**THE
NATIONAL
BOARD**
OF BOILER AND
PRESSURE VESSEL
INSPECTORS

NATIONAL BOARD SUBGROUP INSTALLATION

MINUTES

Meeting of July 19th, 2016
Columbus, OH

FIGURE 3.7.5.1-a
STEAM BOILERS IN BATTERY — PUMPED RETURN — ACCEPTABLE PIPING INSTALLATION

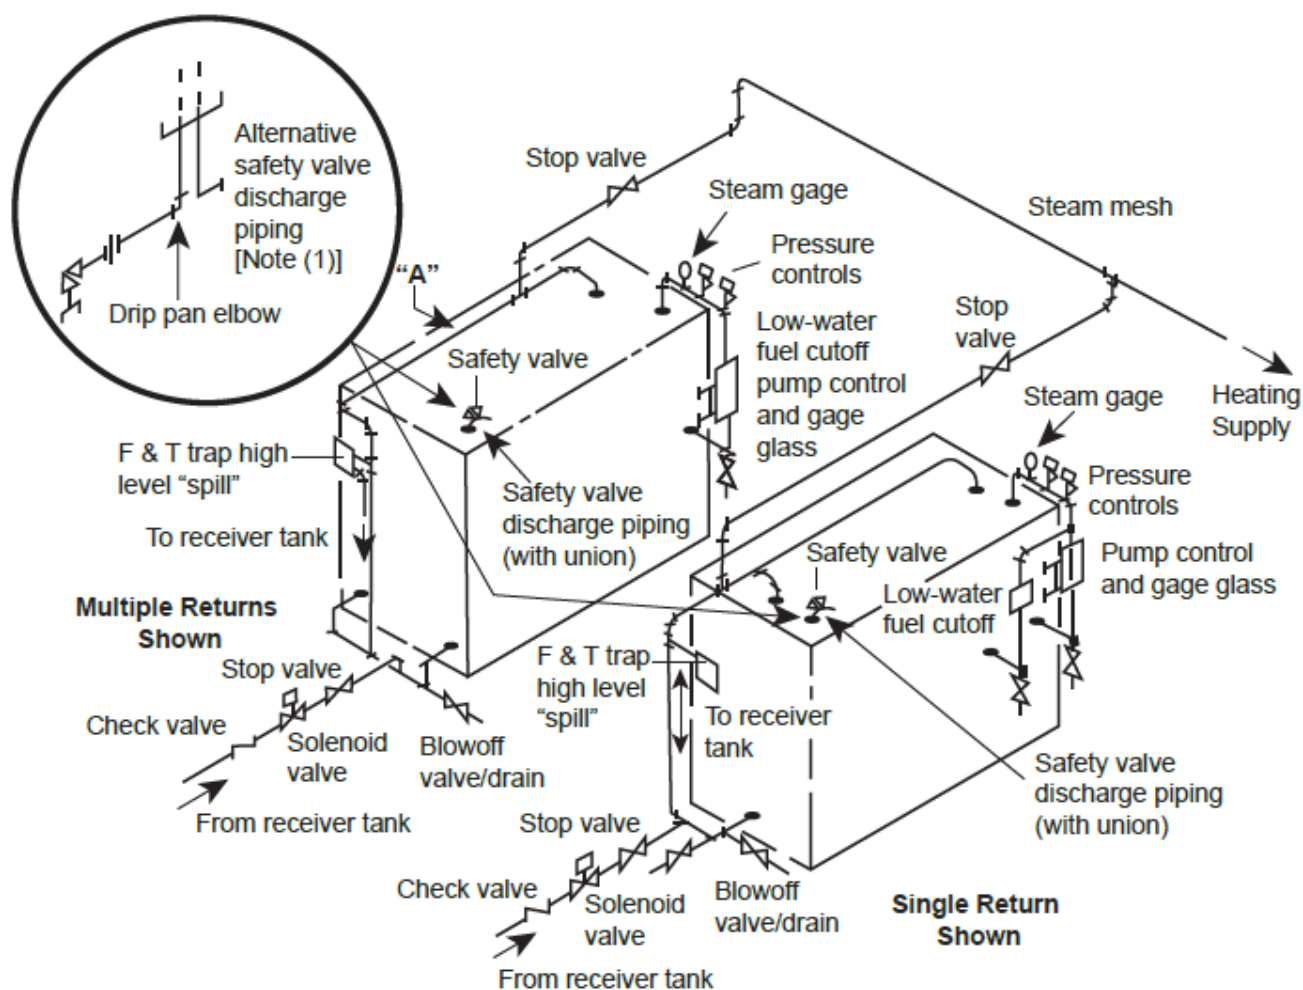
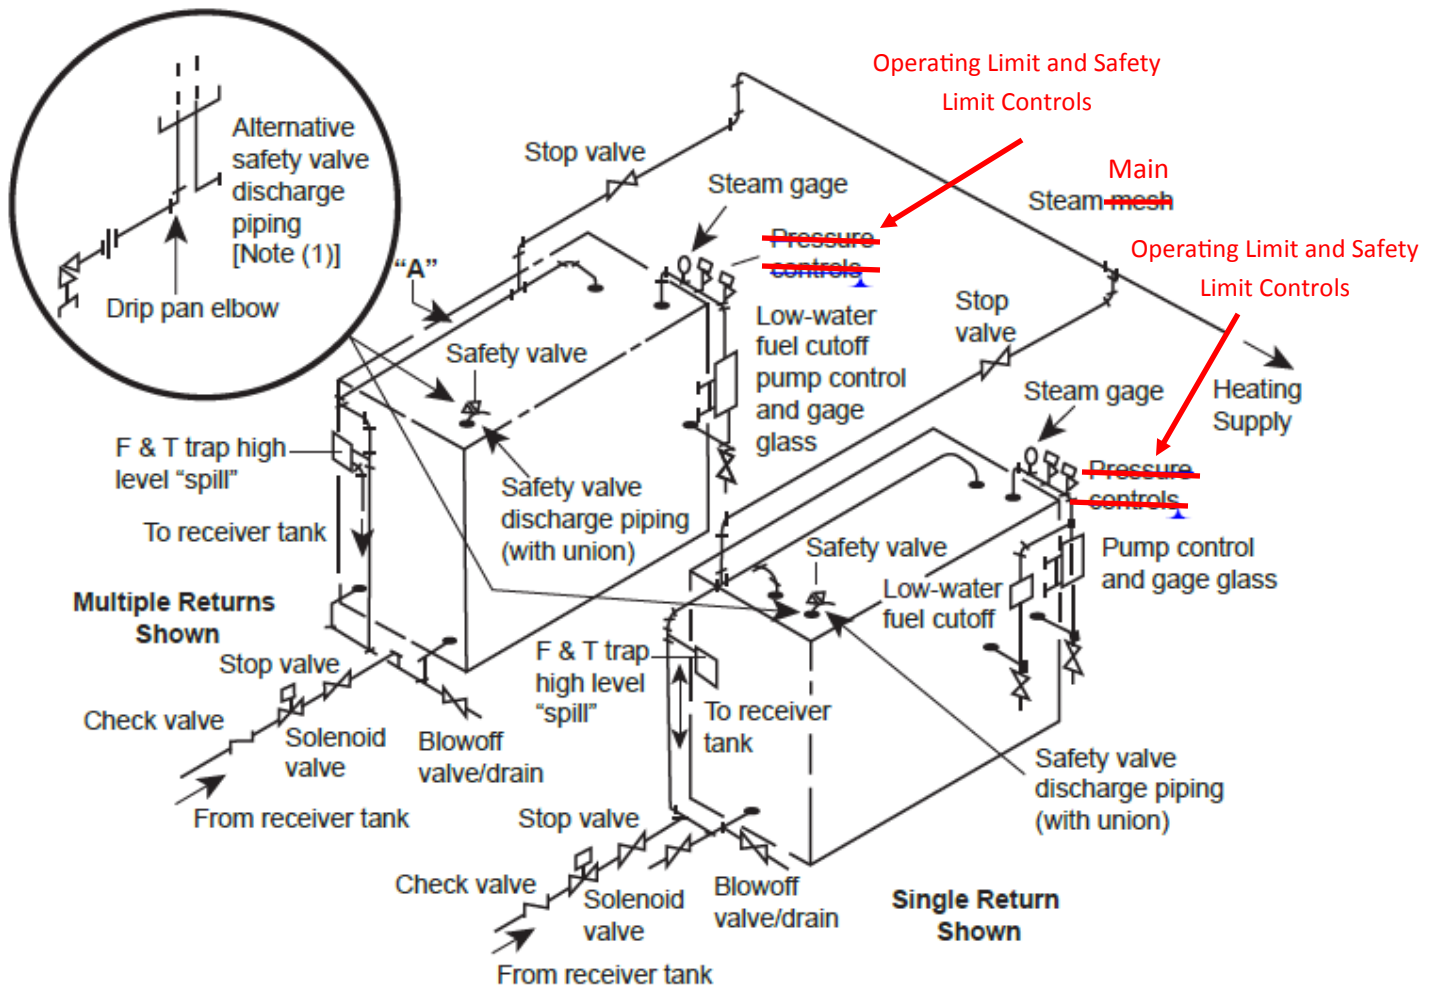
Item Number: NB15-0106	NBIC Location: Part 1, 3.7.5.1	Attachment Pages 2-7
General Description: Address Figure 3.7.5.1		
Subgroup: Installation		
Task Group: B. Moore (PM), T. Creacy, M. Washington, and <u>R. Austin</u>		
Meeting Action: Add R. Austin to the TG. A working group met to discuss and prepare a proposal of editorial changes to figures 3.7.5.1 a, b, and c with regard to pressure controls (operating and high limit). The SG then reviewed and held discussions on the proposal. There was a motion to approve the proposal to the SC. The motion was unanimously approved.

Proposed Changes

FIGURE 3.7.5.1-b
STEAM BOILERS IN BATTERY — GRAVITY RETURN — ACCEPTABLE PIPING INSTALLATION

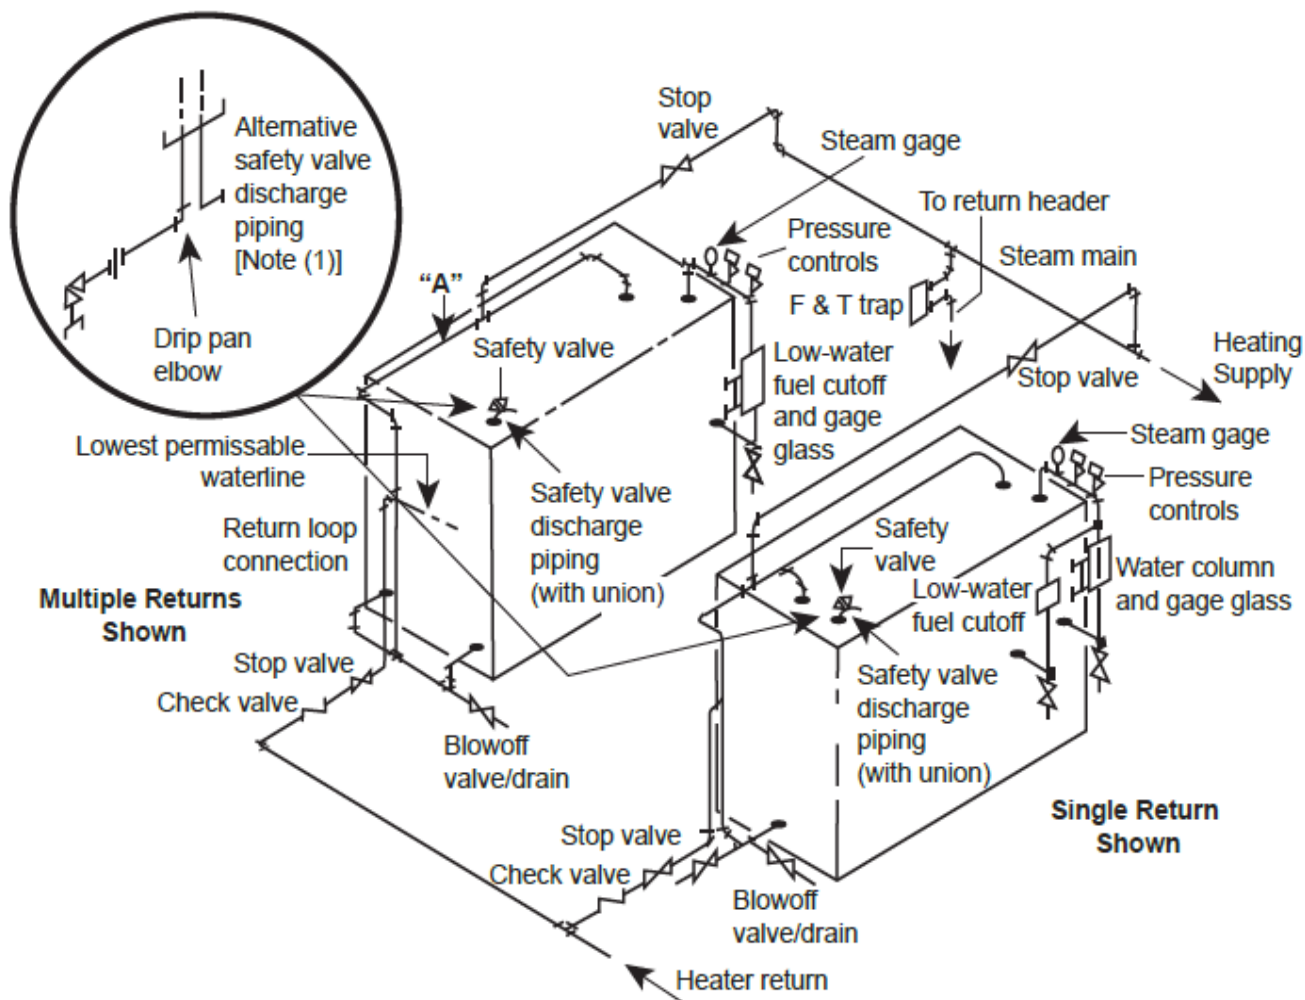
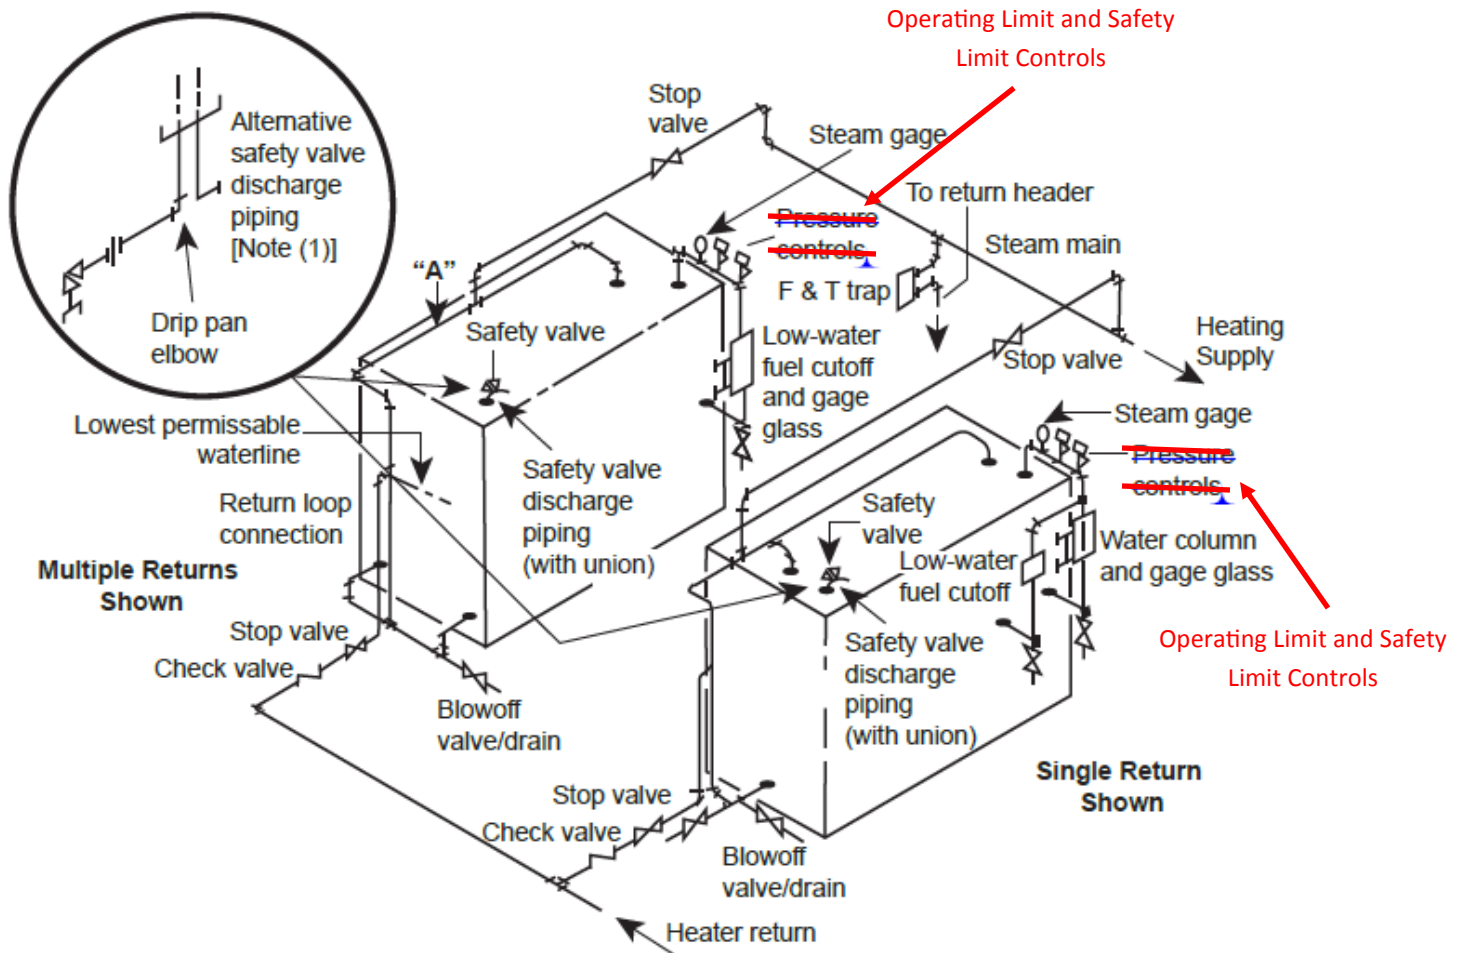
Proposed Changes

FIGURE 3.7.5.1-c
HOT-WATER BOILERS IN BATTERY — ACCEPTABLE PIPING INSTALLATION

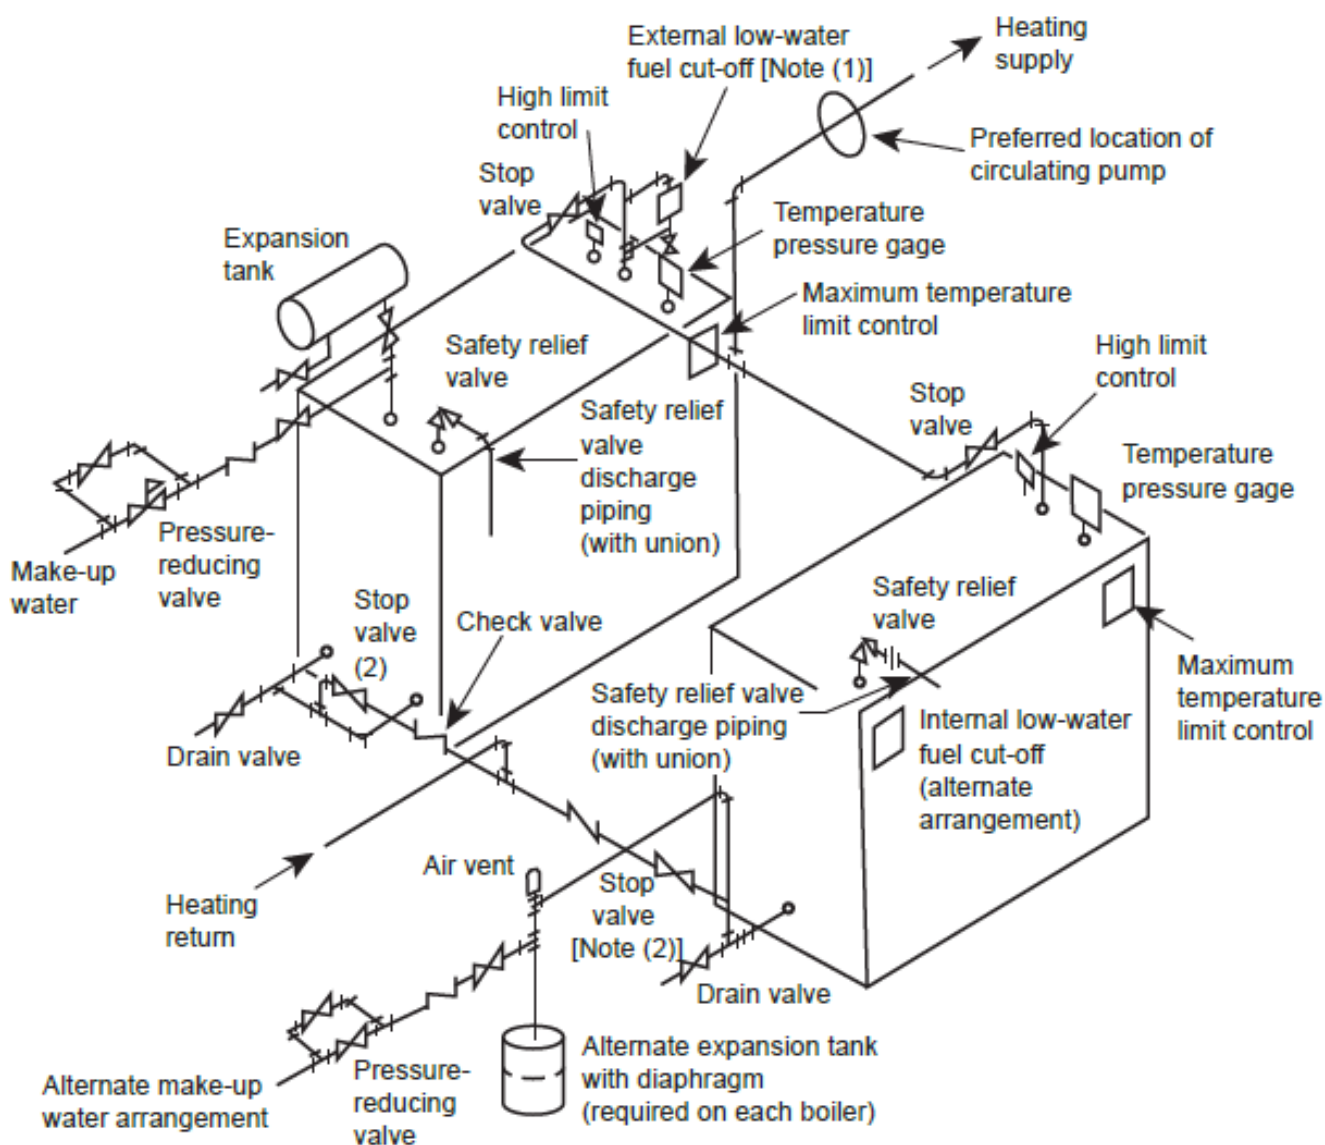
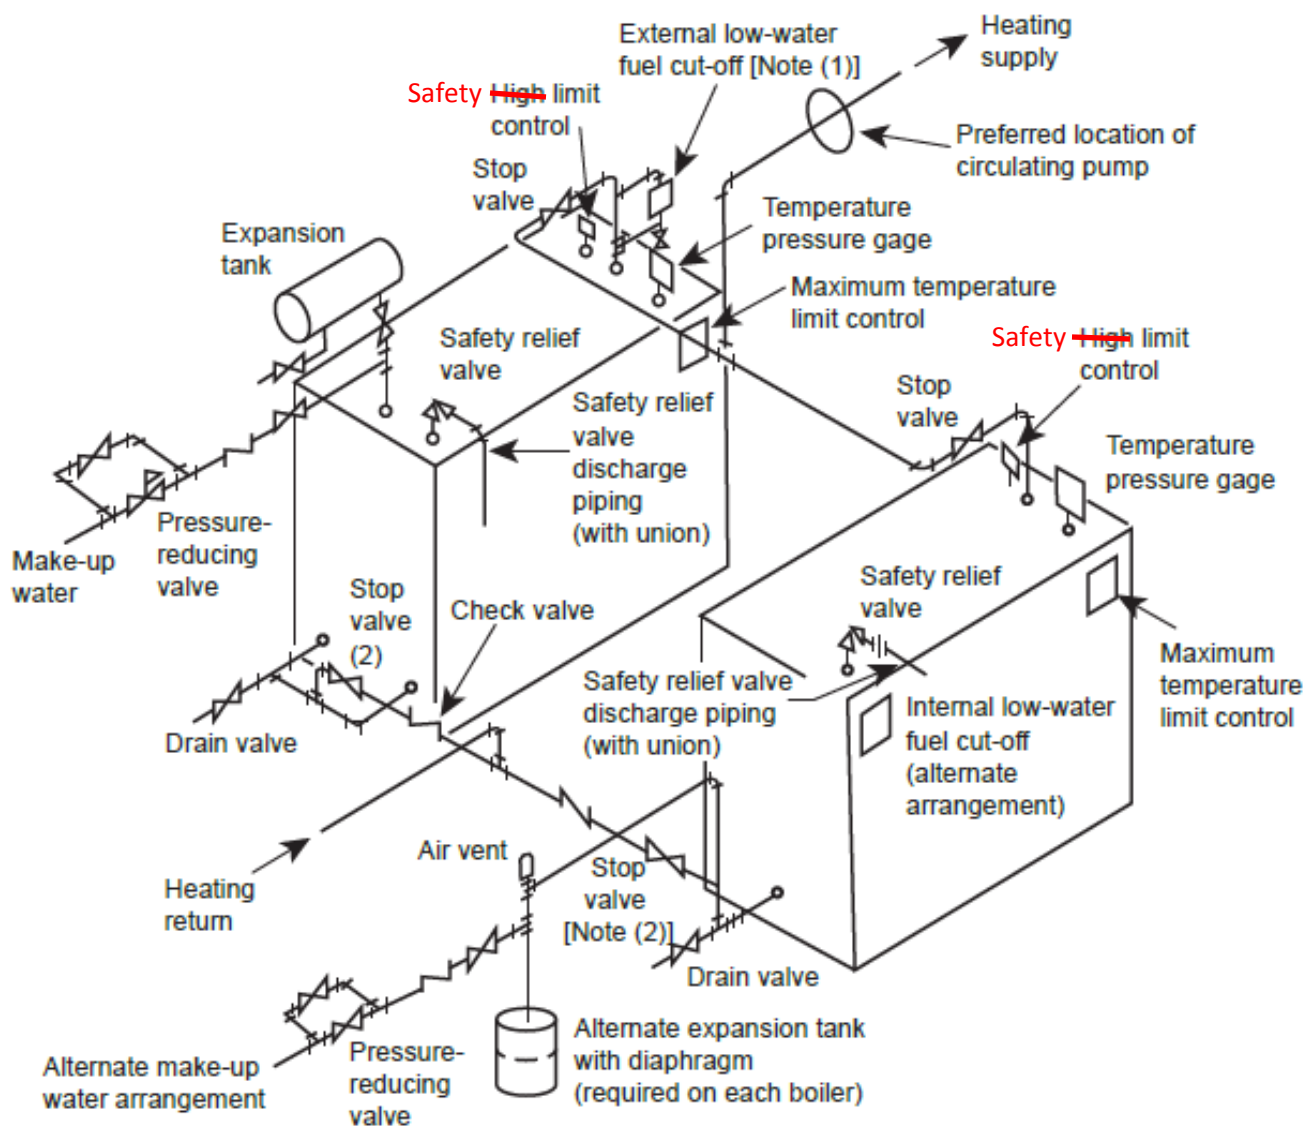
Proposed Changes
